June 1, 2000
PY-CEI/NRR-2492L

Perry Nuclear Power Plant
Docket No. 50-440
License Amendment Request Regarding A Modification To The Emergency Service Water
Alternate Intake Sluice Gate Automatic Opening Function And The Use of a Non-Safety
Inflatable Seal

Summary of Proposed Change

SLUICE GATE SEAL AIR SYSTEM

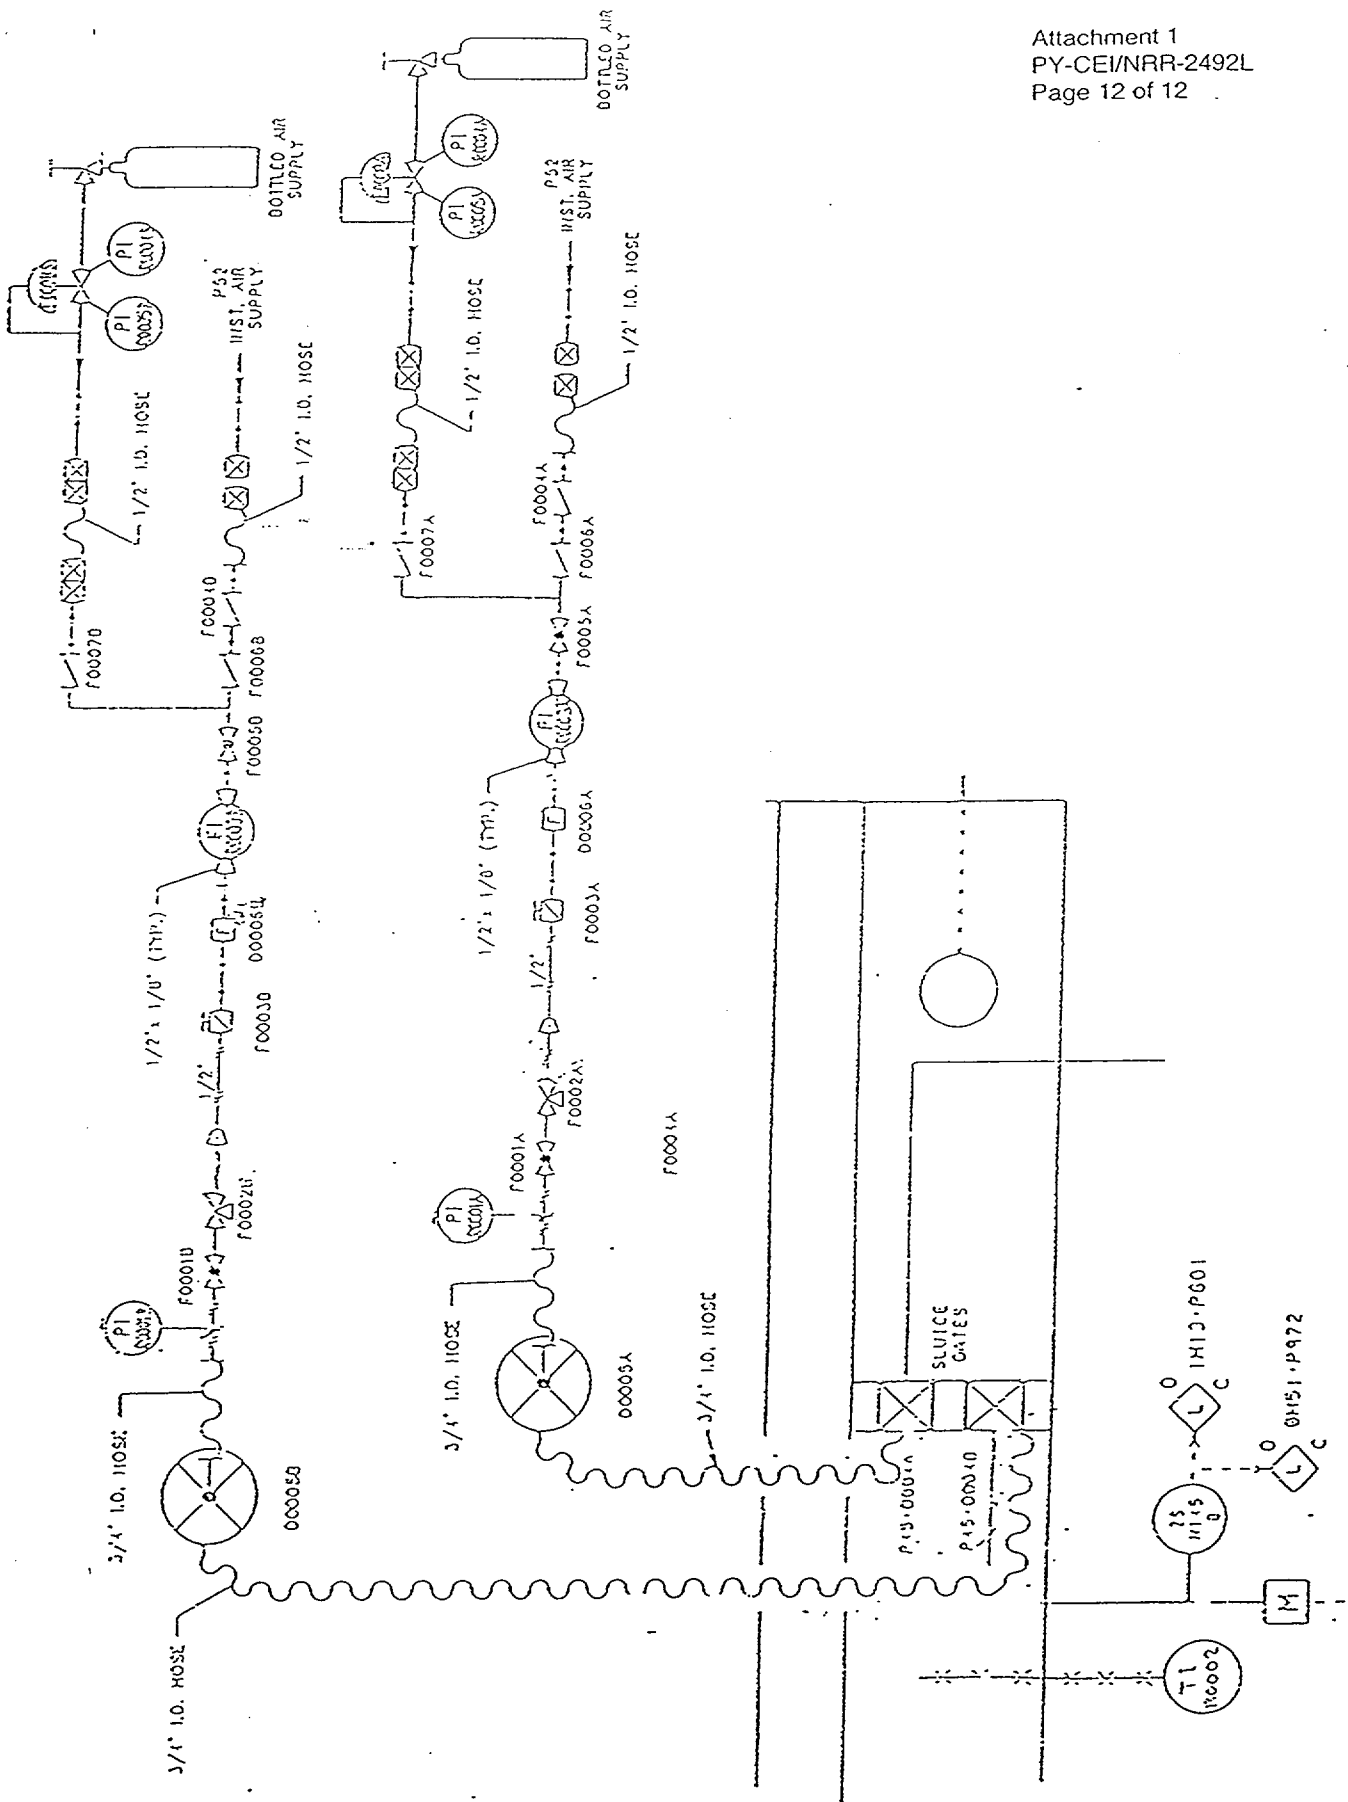
This proposed modification will install a new non-safety inflatable seal and seal retainer on the ESW forebay side of each of the two existing sluice gates. It will also include support equipment such as non-safety hoses and reels to supply air to the seals. A new-safety related Class 1E selector switch will also be installed to enable or defeat the manual raise/lower control switch and the automatic opening signal of the sluice gates. The installation of the seals and the control switch would not result in the requirement for prior NRC approval, provided administrative controls were established to ensure the proposed selector switch was maintained in the AUTO position and the seal was maintained deflated. The administrative controls will ensure that the gates continue to operate in the current mode that allows automatic operation for low forebay level. Defeating the automatic opening signal by placing the proposed selector switch in OFF, and operating with the non-safety seals inflated require prior NRC approval.

The sluice gate seals, inflation system and air supply system are non-safety related (Figure 5). Air is normally supplied by the Instrument Air System and will be backed up by air bottles. The back-up air bottles, part of the air system located locally, ensure the seals remain inflated should the normal air source fail. When the seals are inflated, verification of seal integrity, utilizing instrumentation installed as part of the air system modification, will be provided twice daily. Any significant leaks in the sealing system will be identified and repaired. Since the air supply system is non-safety, two check valves, in series in the instrument air supply system, will be provided for isolation and redundancy. The redundant check valves will prevent the seals from becoming depressurized during a loss of instrument air event. The check valve integrity will be verified on an annual basis, prior to inflating the seals. Verification of seal integrity will ensure that the inflatable seals are performing their intended isolation function during normal plant operation, thus the ESW forebay temperature will not exceed its design temperature limit. Chapter 15 of the USAR states that non-safety systems are assumed to be available to mitigate plant transients. Verification of seal integrity and verification of an adequate back-up air supply system provides assurance that the non-safety seals will be available to prevent leakage during transient mitigation and therefore the operability of the ESW system will be assured.
